Product / Process Change Notification

N° 2019-191-A

Change of shipping packaging for EconoPACK™ / EconoPIM™ / EconoBRIDGE™ and EconoDUAL™ Pressfit

■ Econo2

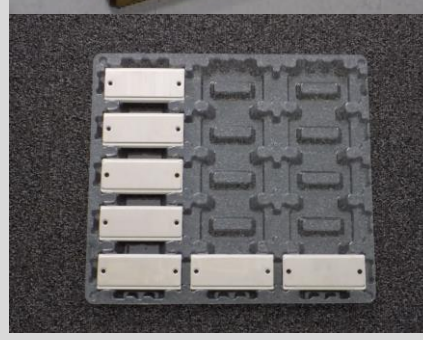
Size: 355 x 275 x 45 mm
Module per box: 10pcs
Orientation: Baseplate up

Size: 390 x 350 x 40 mm
Module per box: 15pcs
Orientation: Baseplate up

■ EconoDUAL™ Pressfit

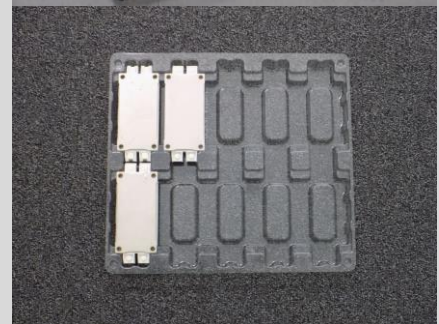
Size: 300 x 205 x 85 mm
Module per box: 6pcs
Orientation: Baseplate up

Size: 390 x 350 x 40 mm
Module per box: 10pcs
Orientation: Baseplate up
